# KING SOOPERS FUEL #84 AND CONDITIONAL USE

**COVER SHEET**

SITE PLAN

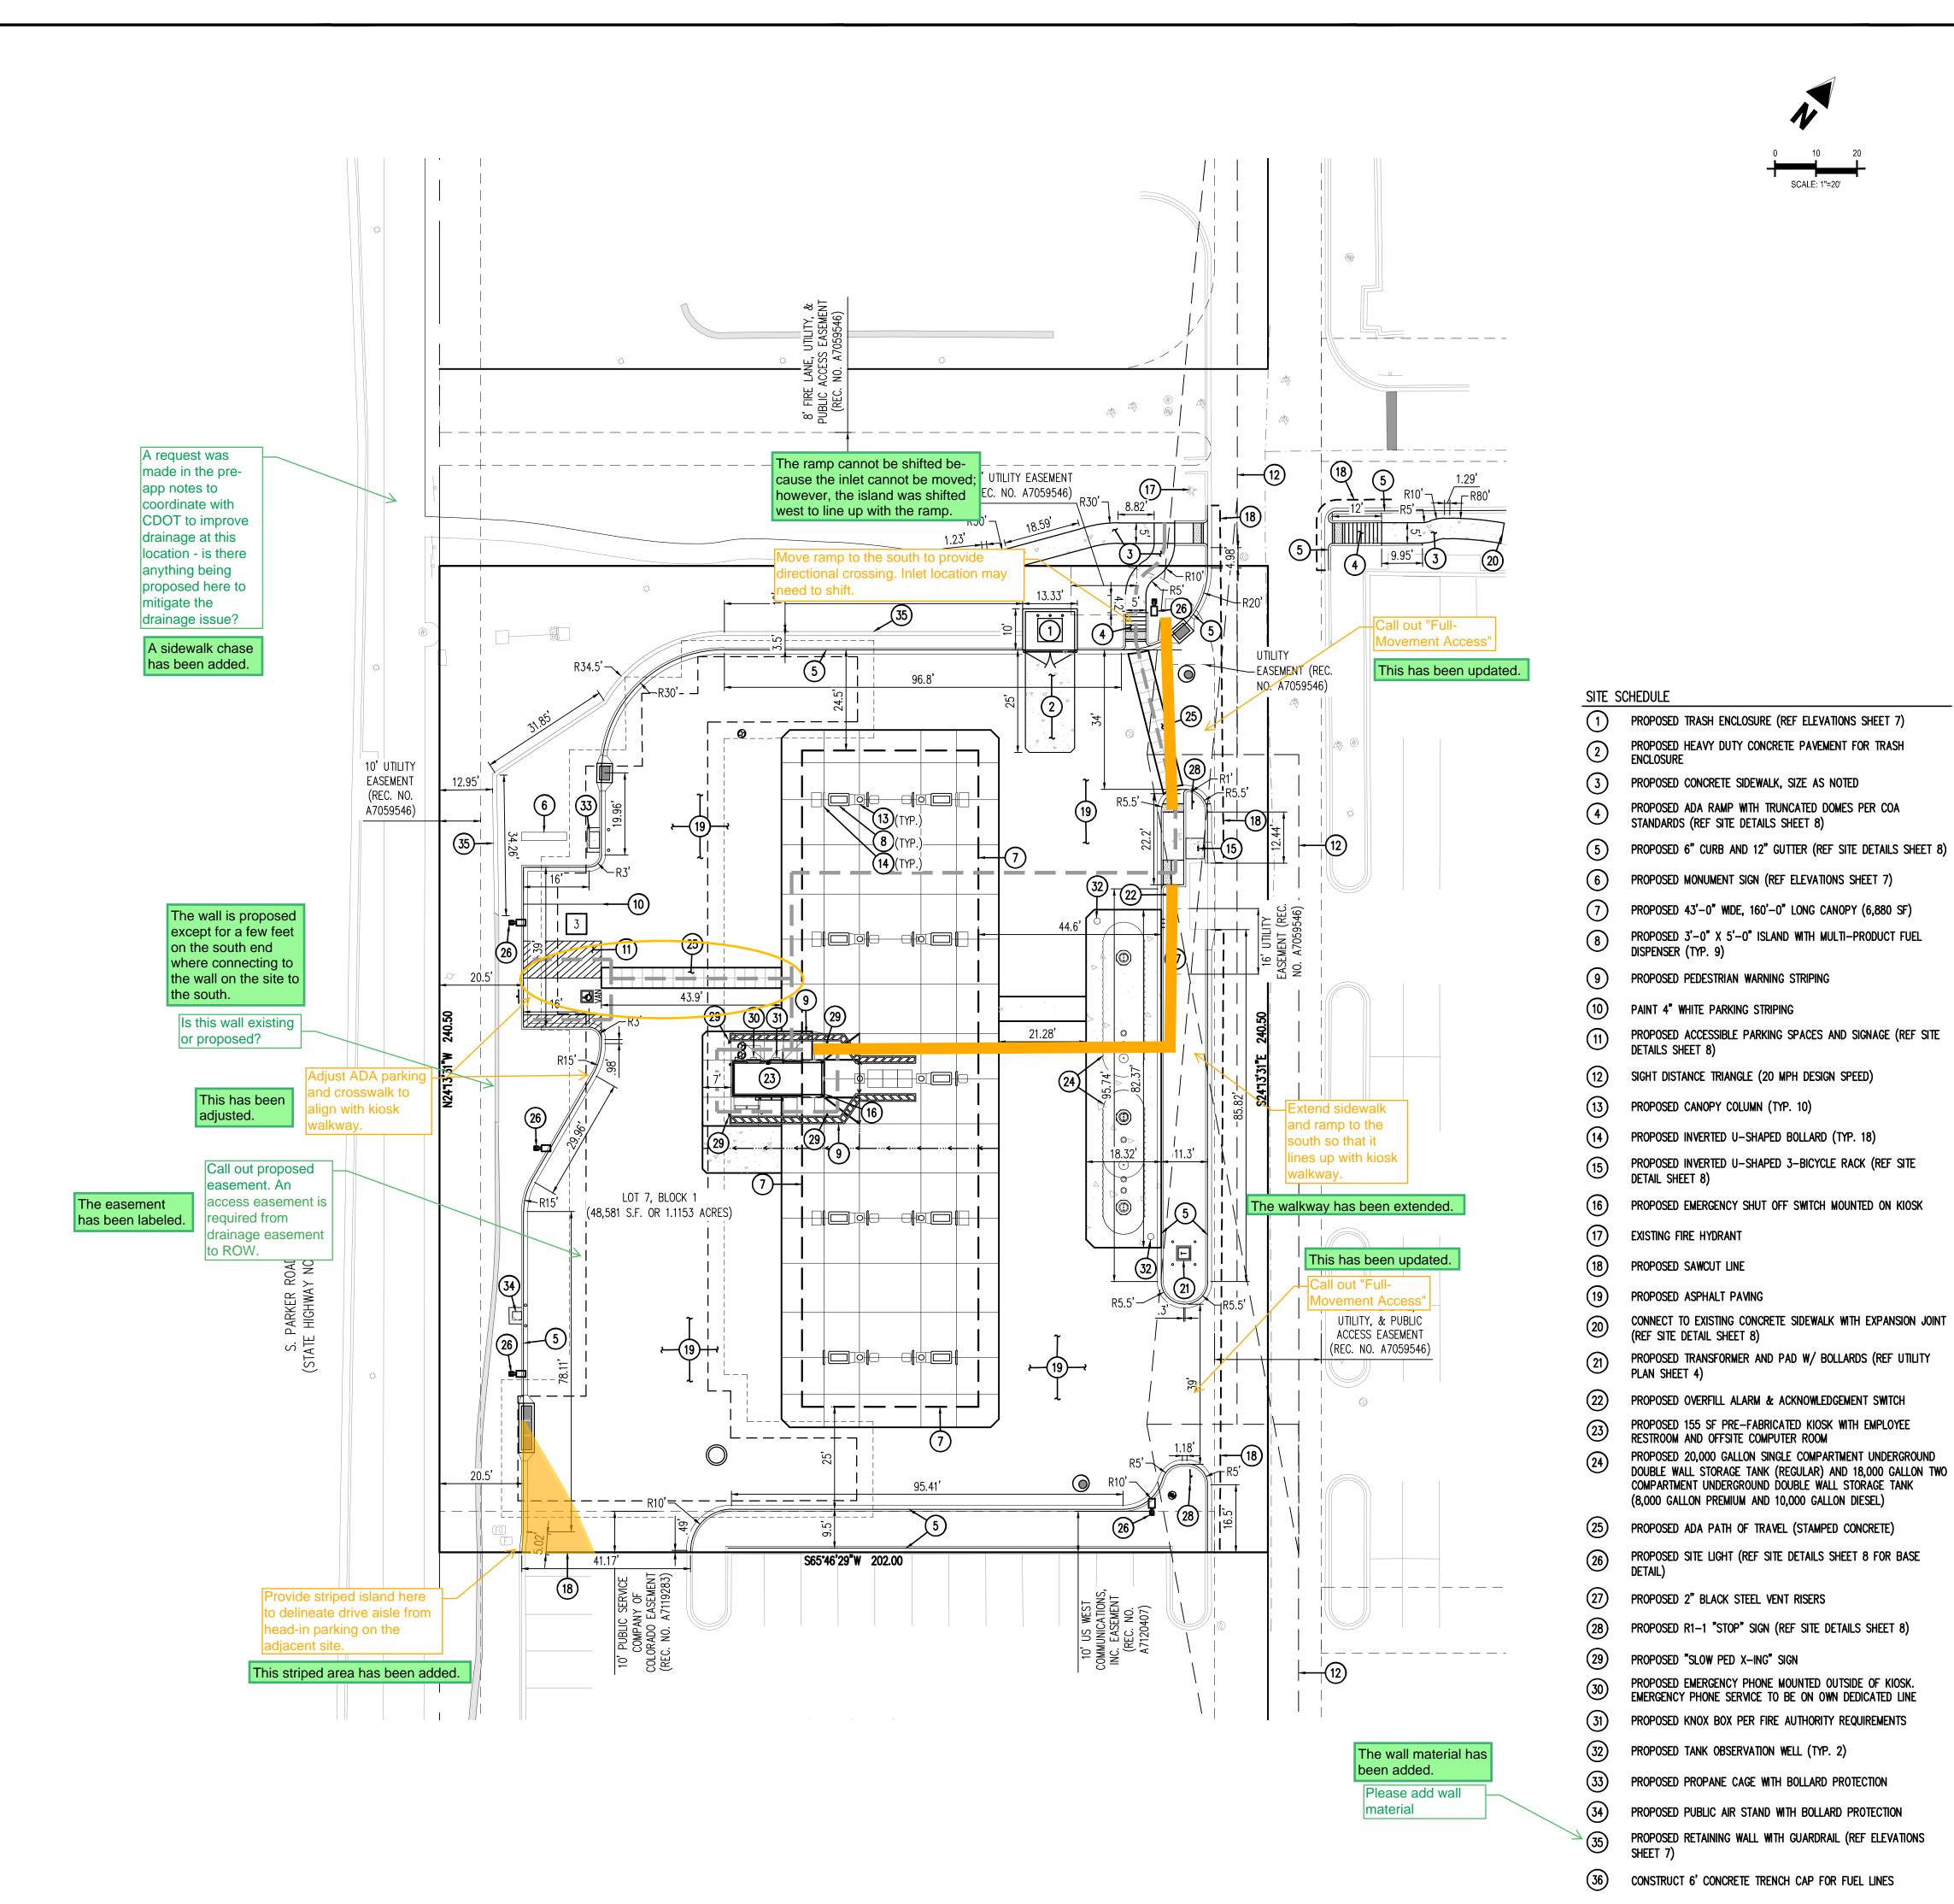
The site plan will not be approved by drainage letter/report is approved

Remove copyright

typical all sheets)

narder for reviewers to give commen The next application will not be accepted if this is not done.

umber of stories add to the table. Planning recommends breaking the dat

table into required vs provided sections

Noted. Thank you.

been updated

Checked By: SEPTEMBER 2021 GRADING PLAN

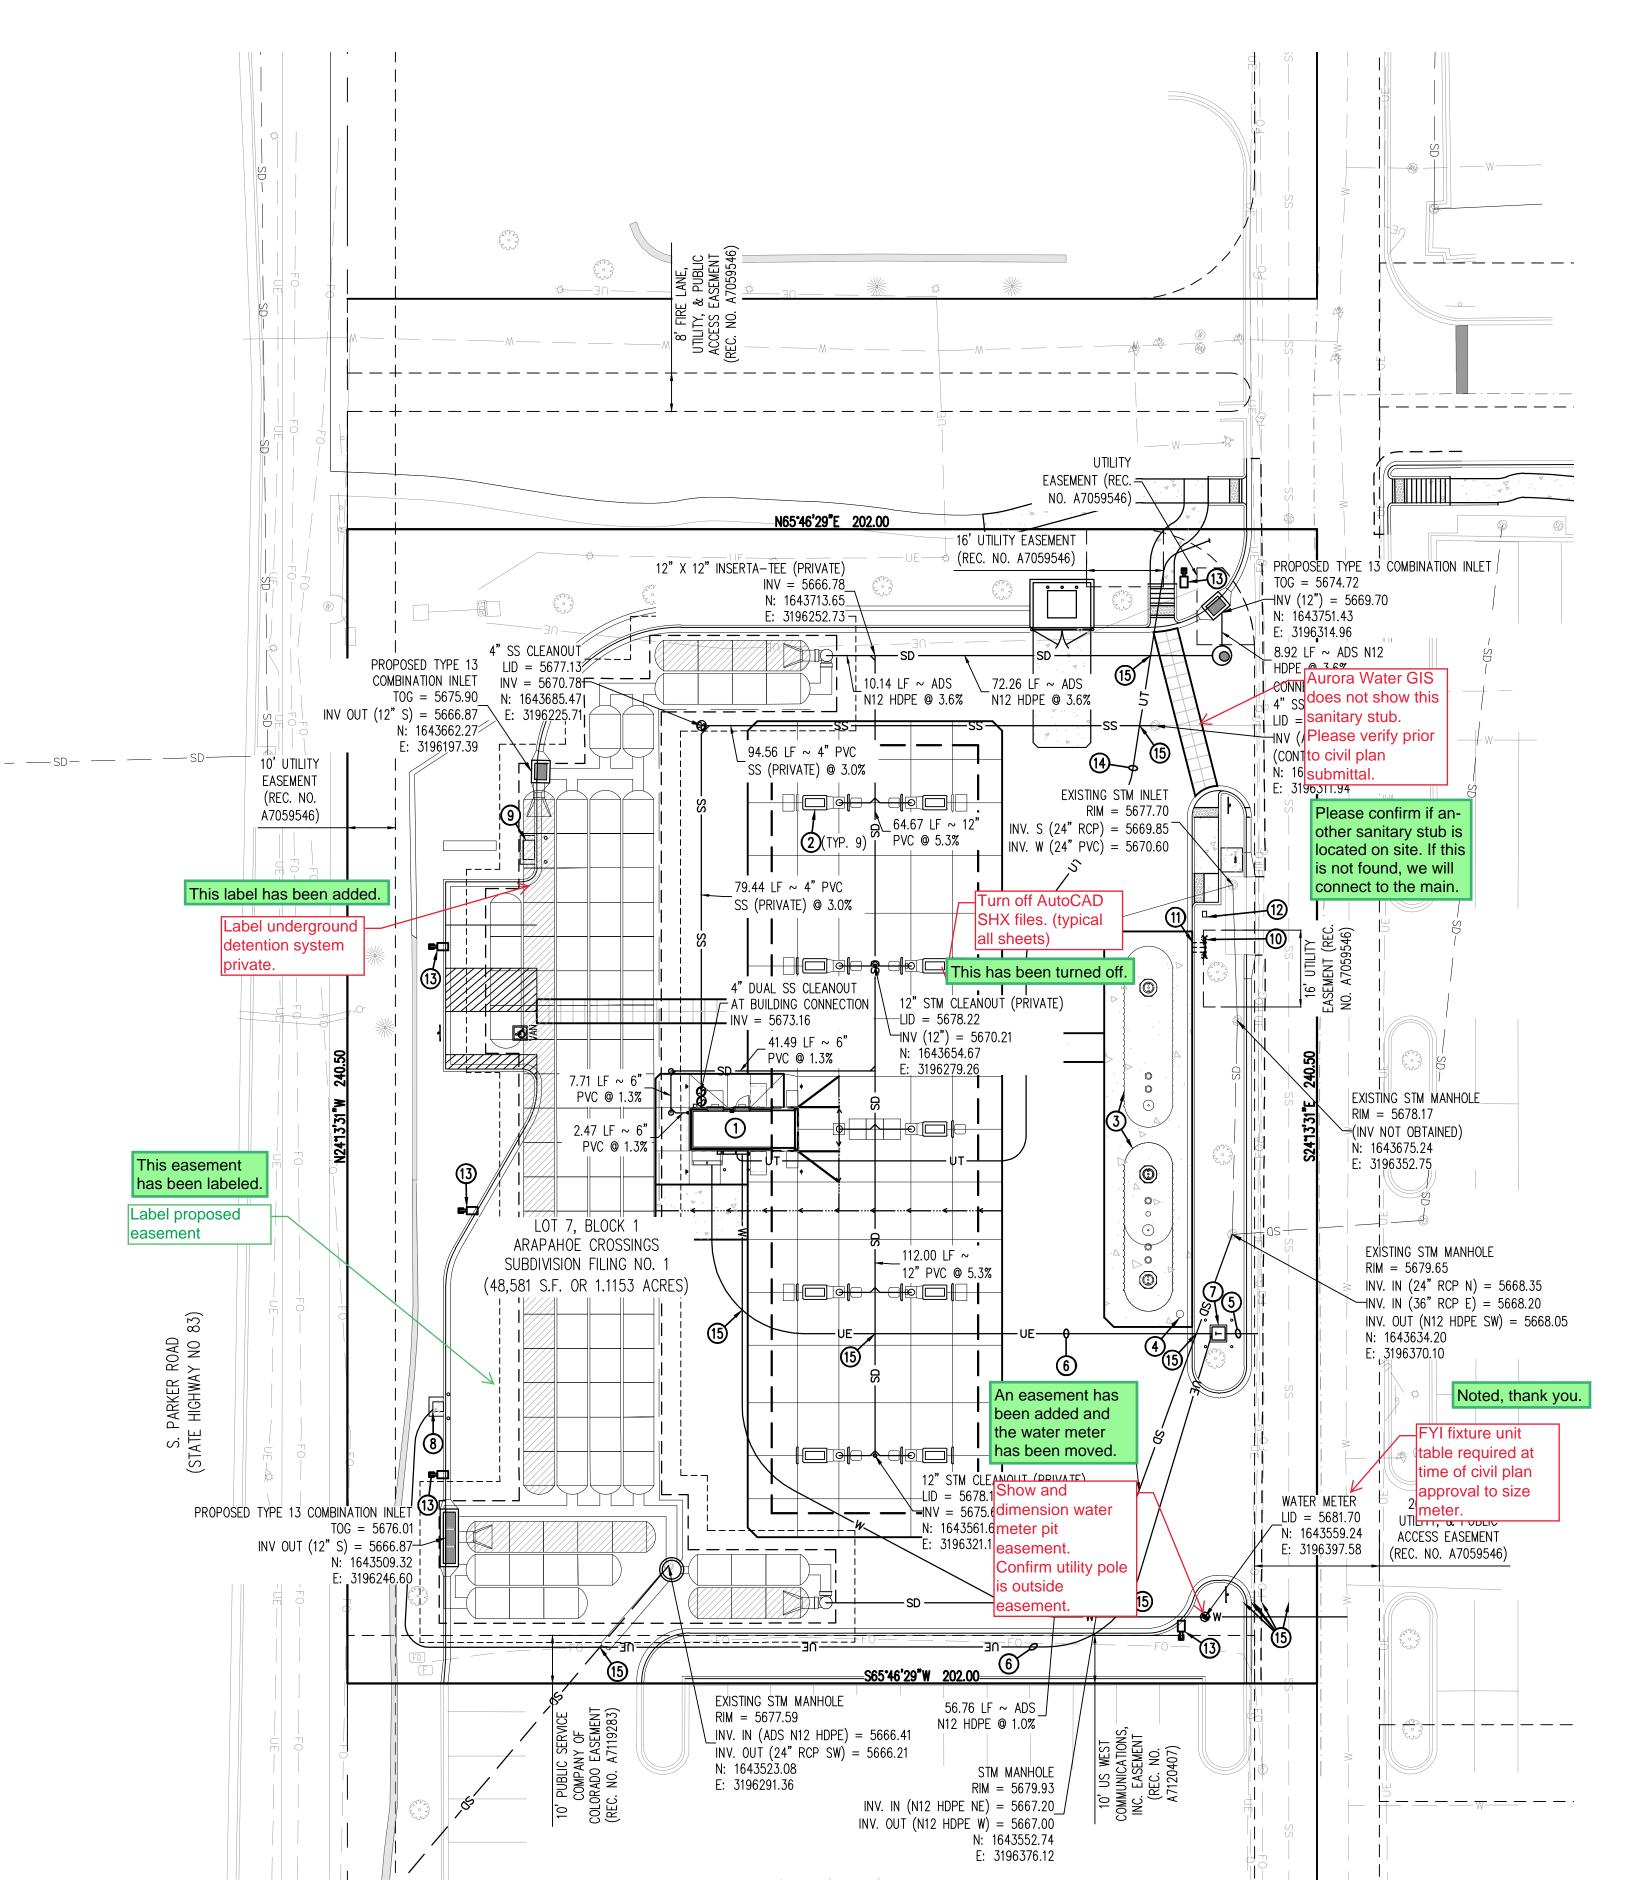
Add a note indicating if the storm sewer system is public or private and who will maintain it.

A note has been added.

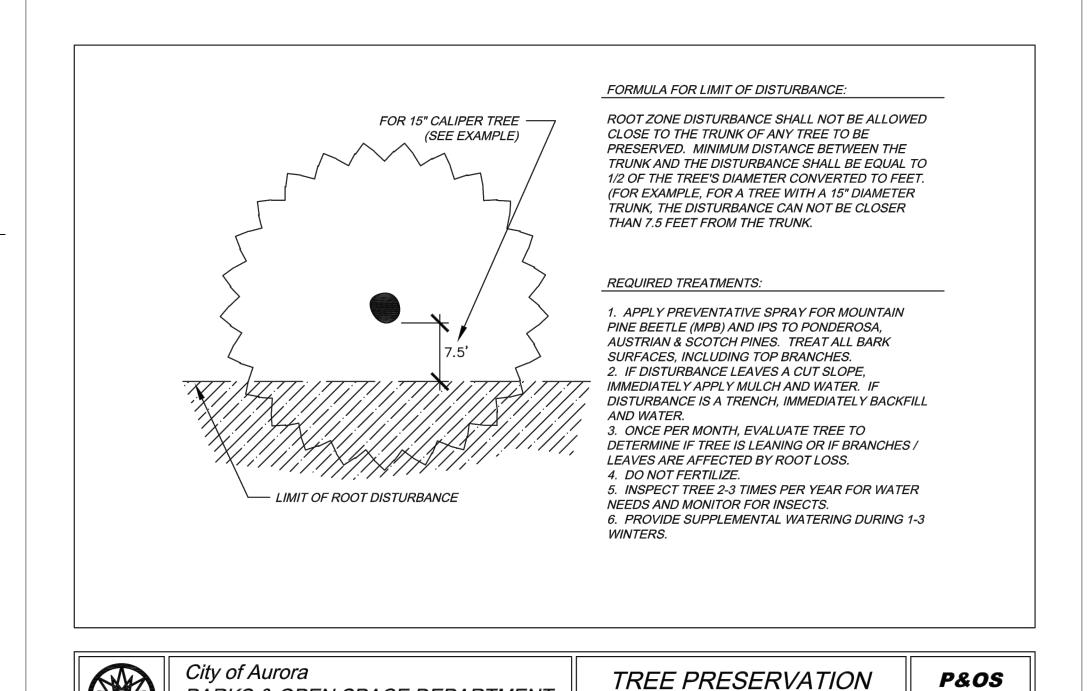
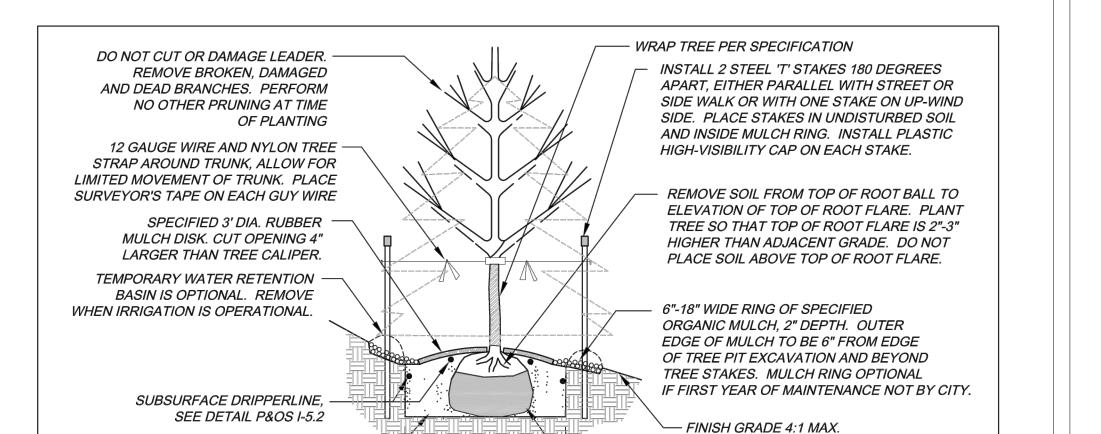
Add a note indicating if the storm sewer system is public or private and who will maintain it.

$\sim$ Delete the above notes. Irrigation notes do not belong on the landscape plan and the utility notes are contractor related and the City does not review construction related notes.

This has been added.

GALLOWAY RESPONSE: NOTES HAVE BEEN
